## HILL VALLEY - PHASE 2B

CITY PROJECT NO. 15860  
CONTRACT NO. 9680

#### REVISION 1 - 04/29/26

#### REVISION 2 - 05/28/26

15860  
 P-8

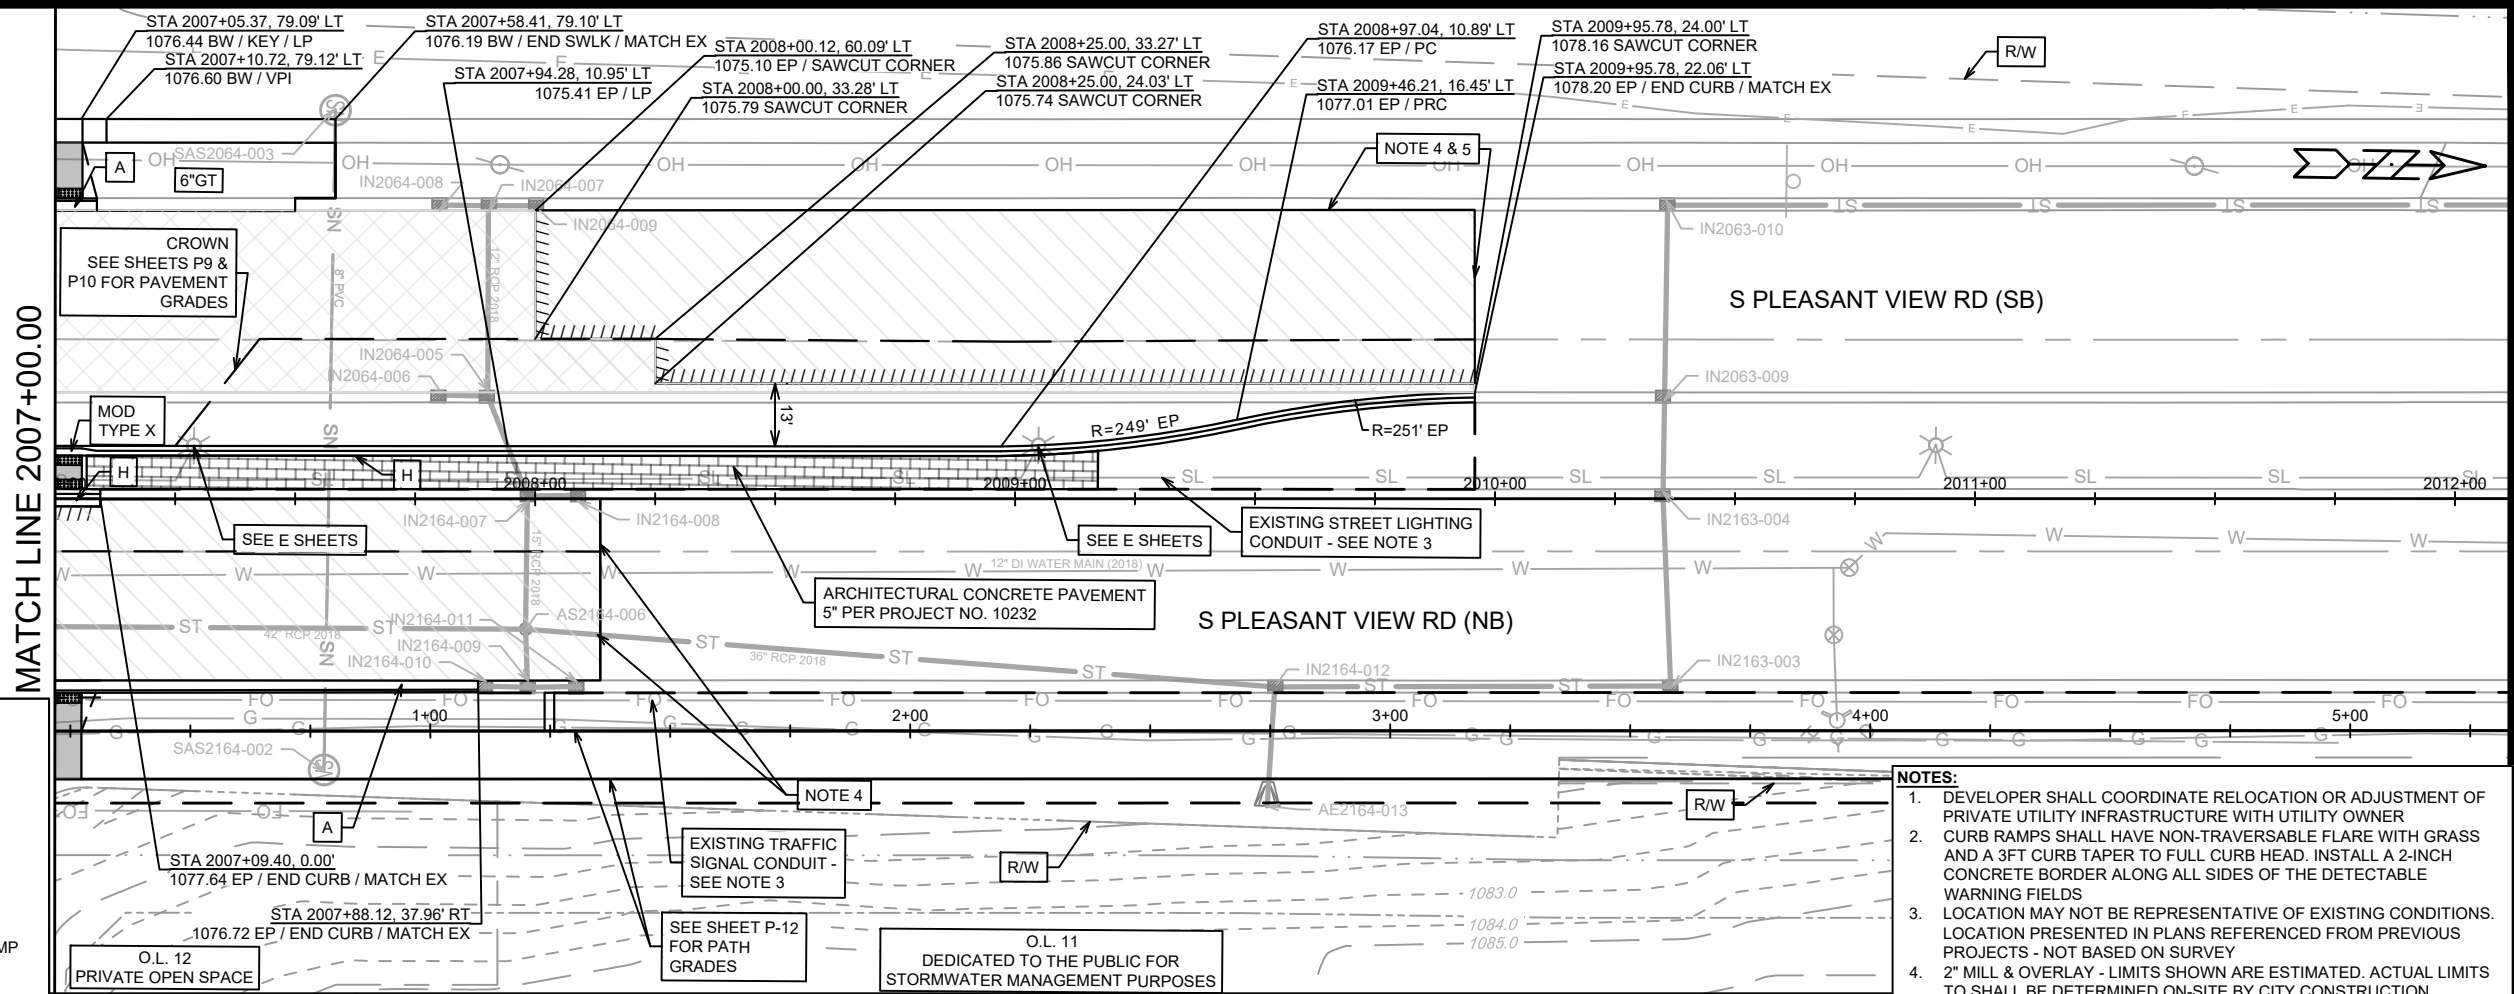
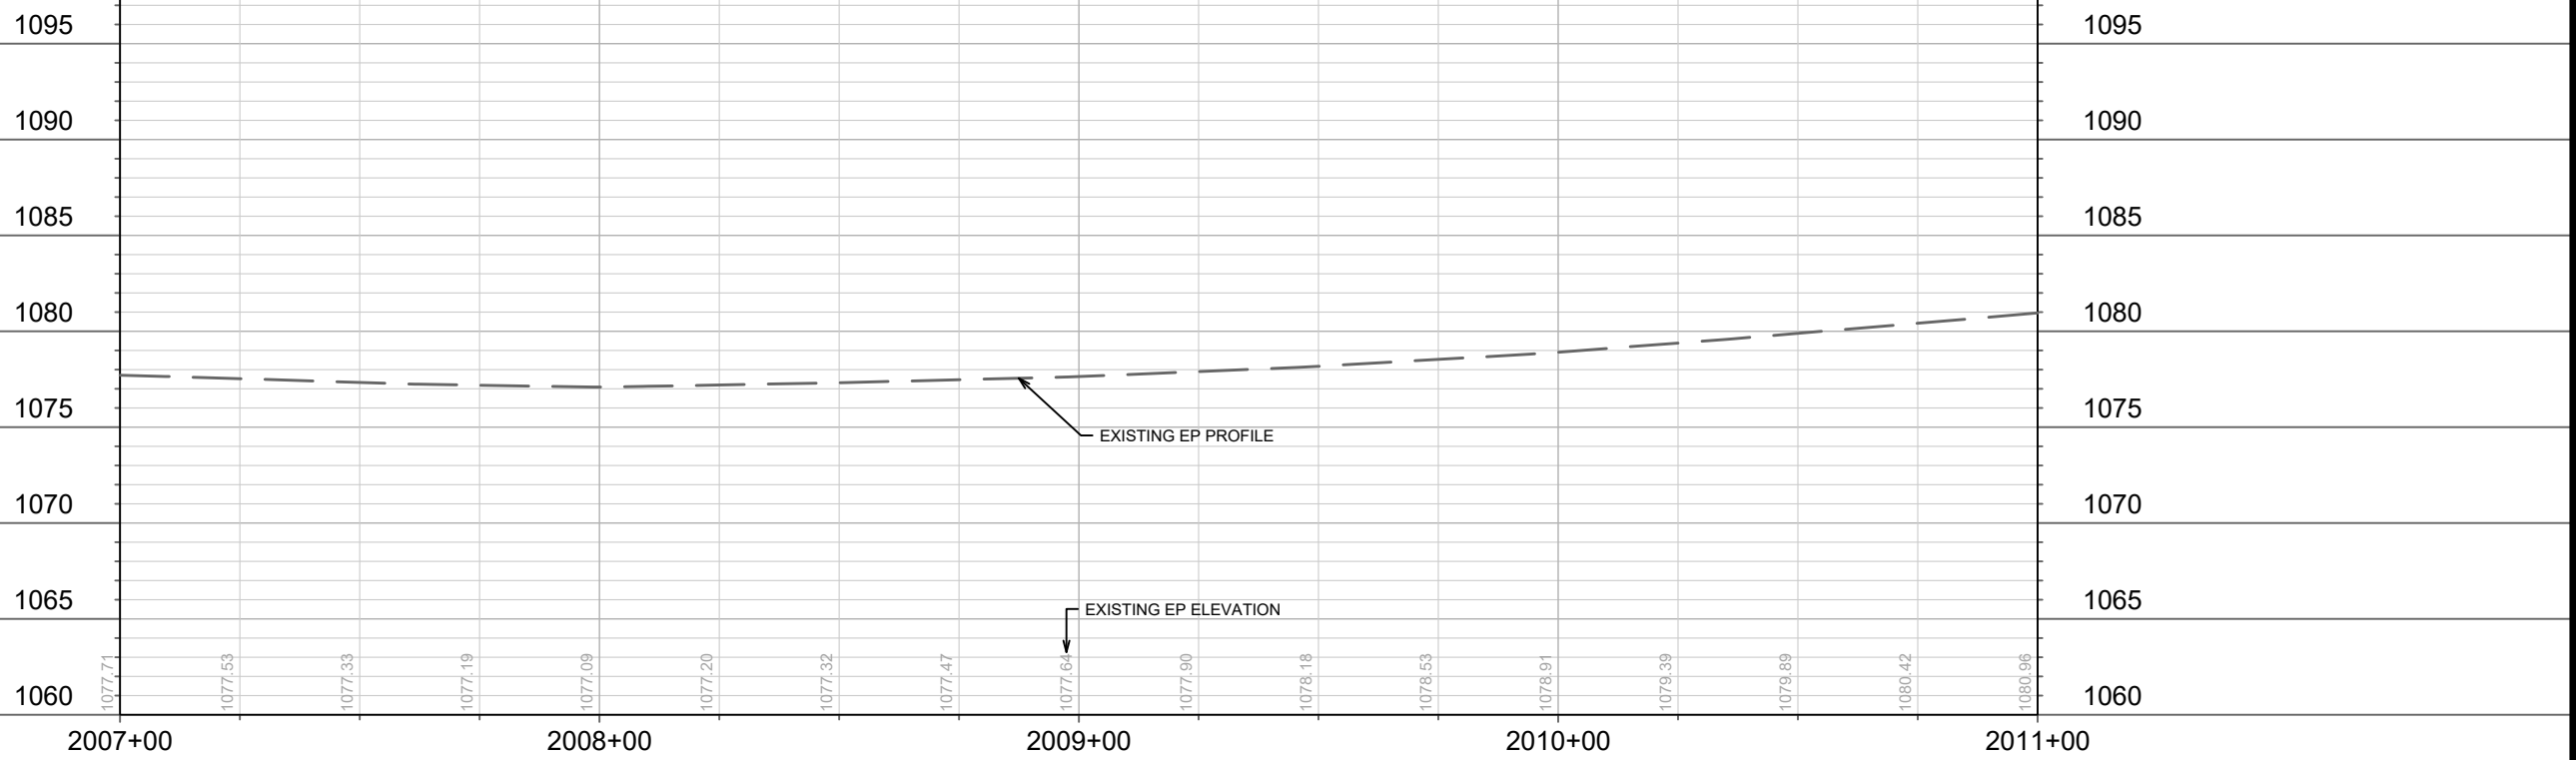
**REVISION 3 - 06/29/26**  
**- UPDATED ROW LABELS**

15860  
 MADISON, WI  
 CONTRACT NO: 9680  
 PLAN & PROFILE - S PLEASANT VIEW ROAD (SIDEWALK)  
 HILL VALLEY - PHASE 2B  
 M:\DESIGN\Projects\15860\CAD\Streets\15860EN-PnP.dwg  
 15860  
 P-11

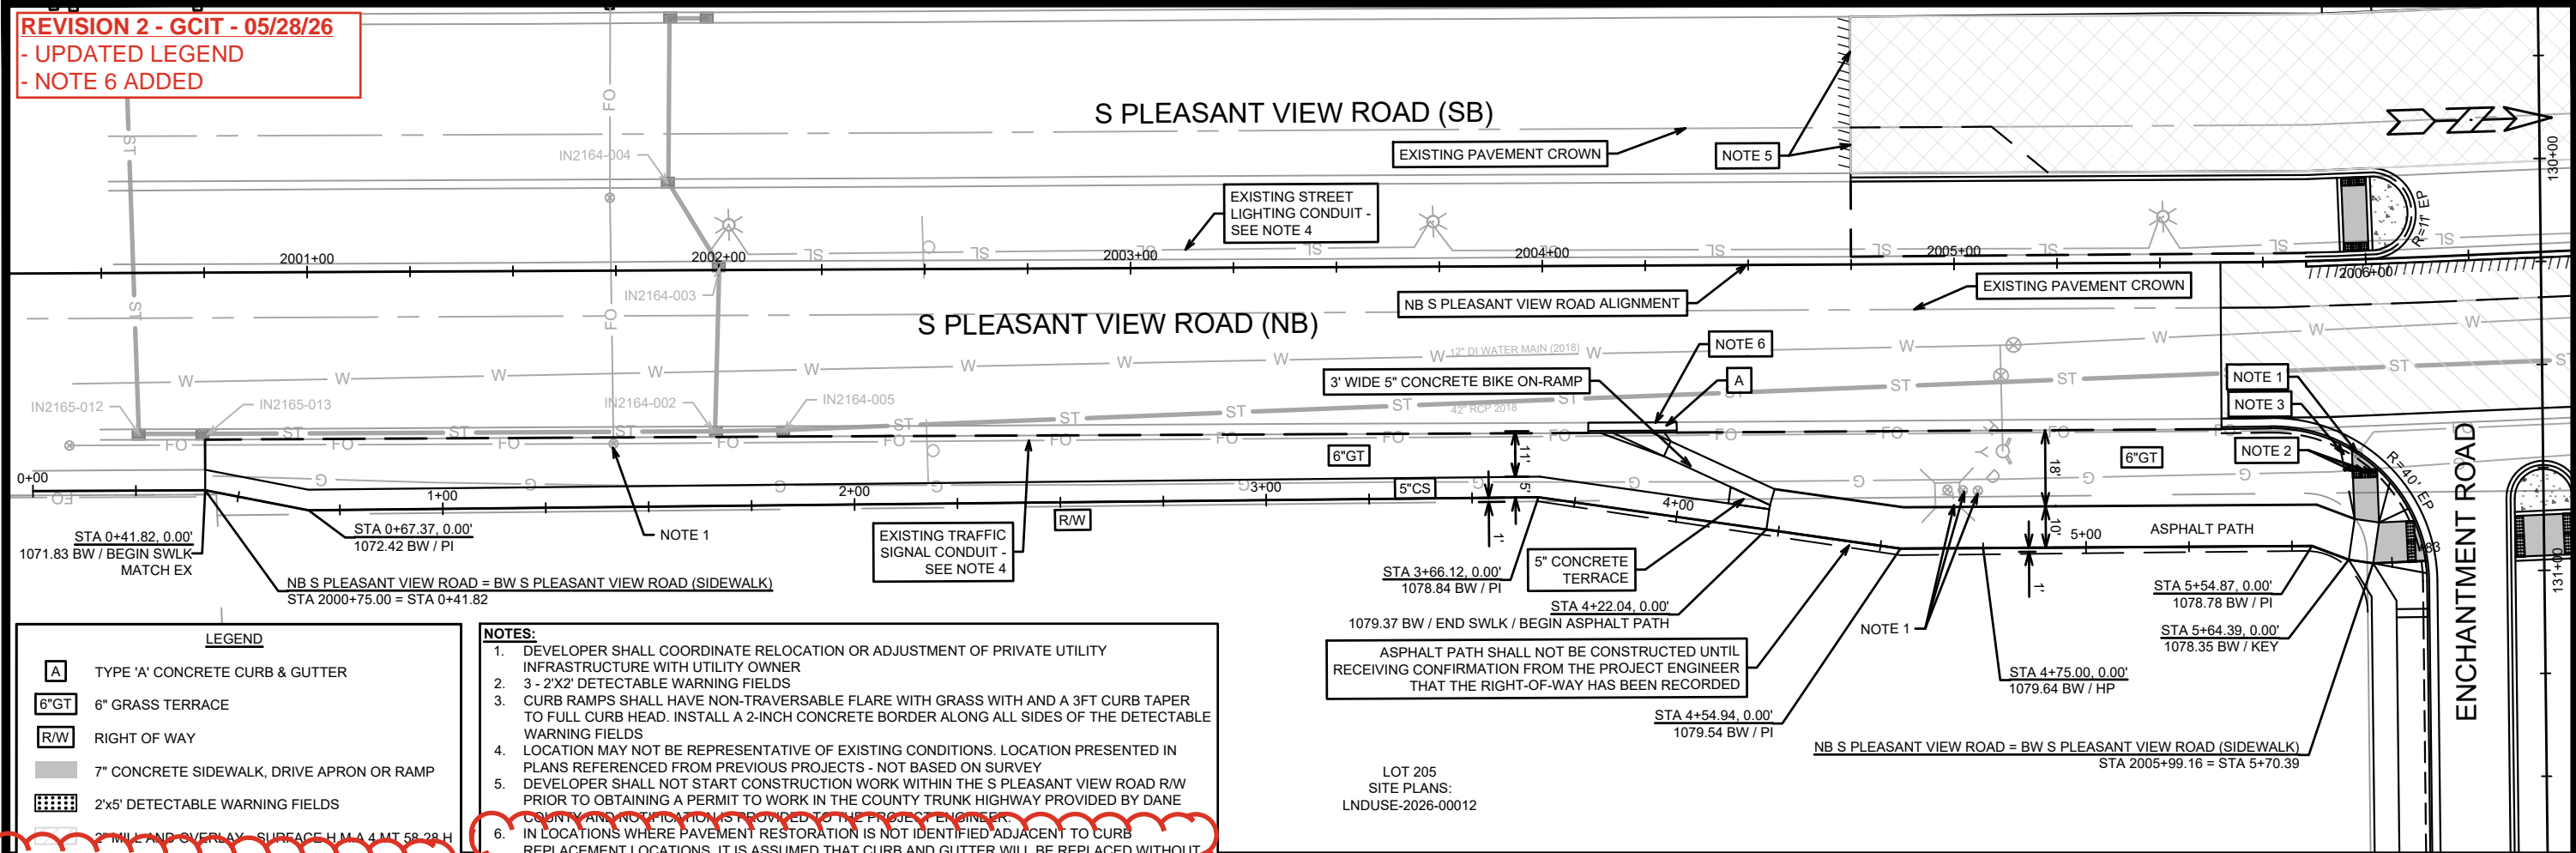
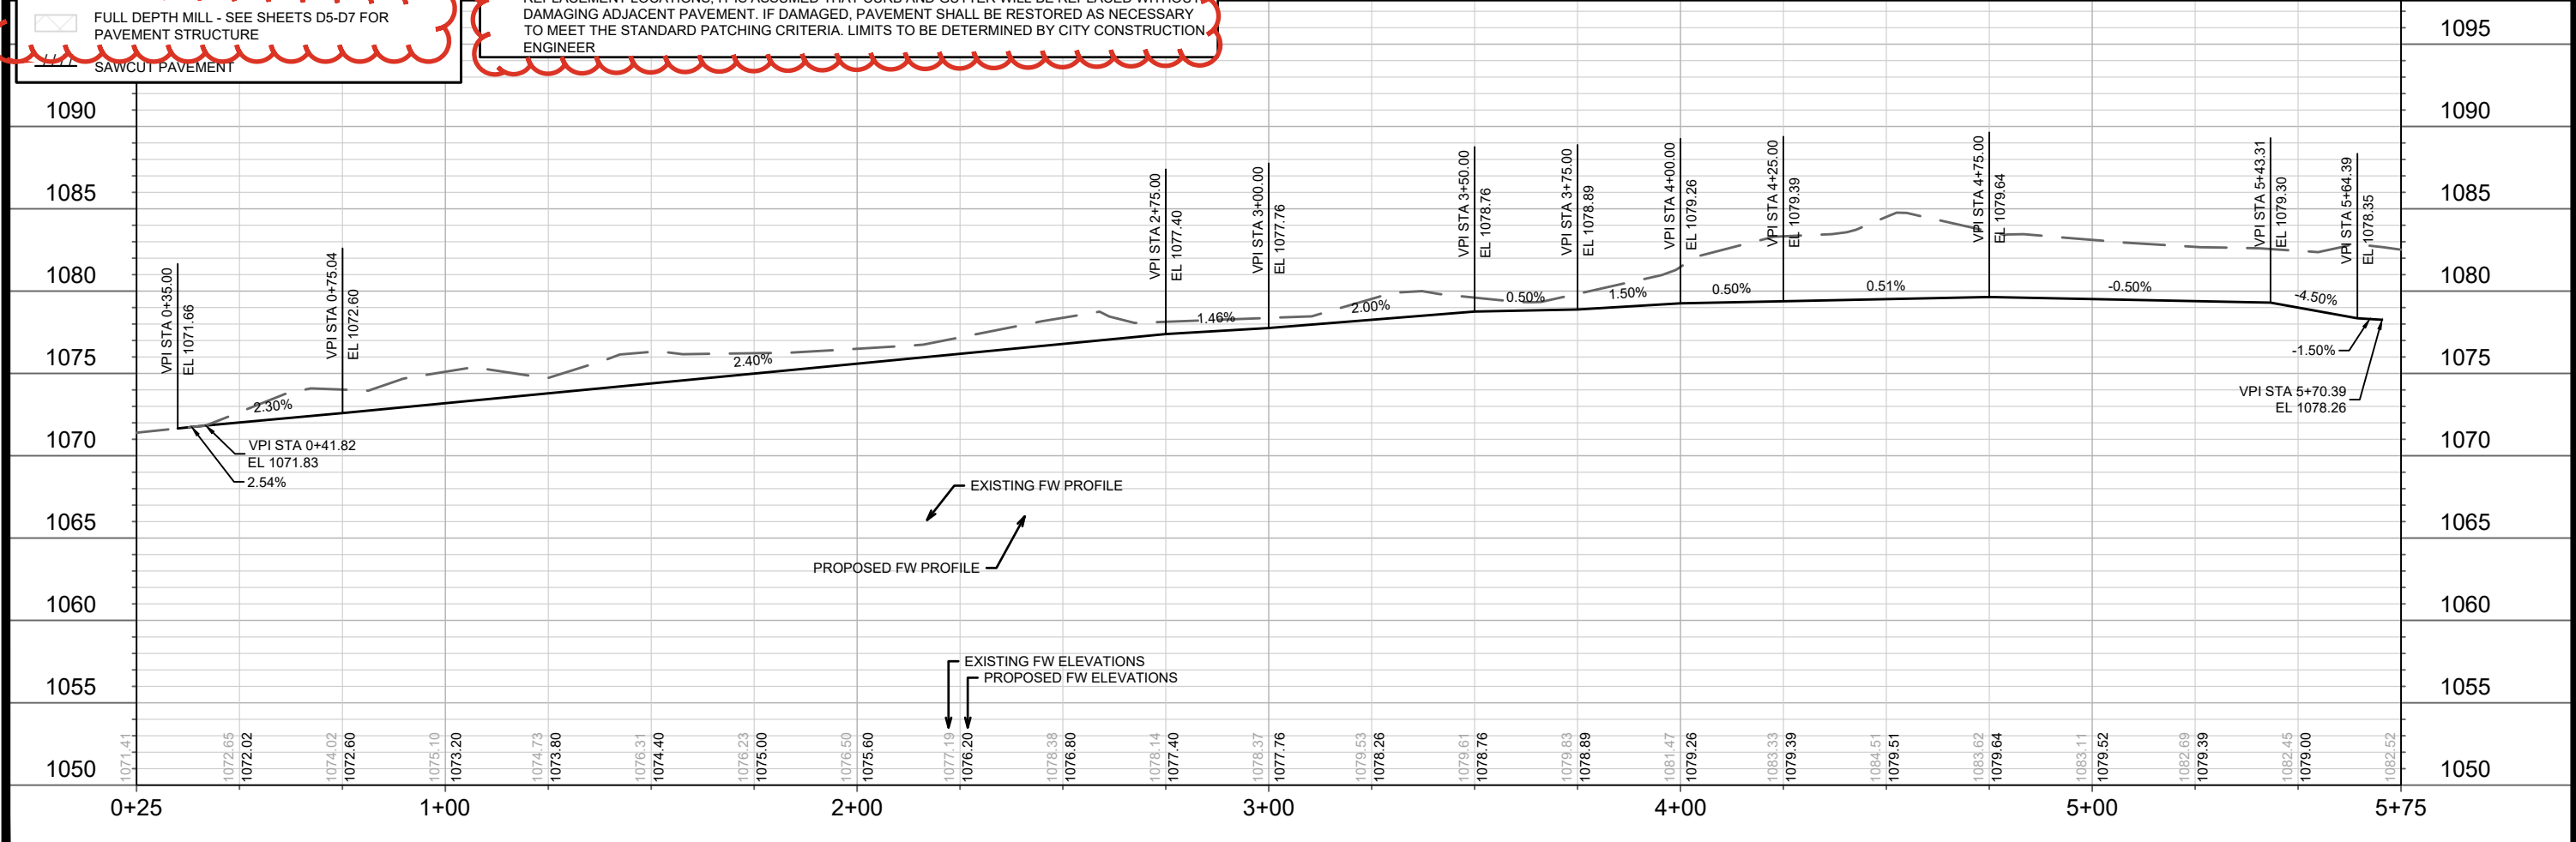
**REVISION 2 - GCIT - 05/28/26**  
 - UPDATED LEGEND  
 - NOTE 6 ADDED

6. IN LOCATIONS WHERE PAVEMENT RESTORATION IS NOT IDENTIFIED ADJACENT TO CURB REPLACEMENT LOCATIONS, IT IS ASSUMED THAT CURB AND GUTTER WILL BE REPLACED WITHOUT DAMAGING ADJACENT PAVEMENT. IF DAMAGED, PAVEMENT SHALL BE RESTORED AS NECESSARY TO MEET THE STANDARD PATCHING CRITERIA. LIMITS TO BE DETERMINED BY CITY CONSTRUCTION ENGINEER
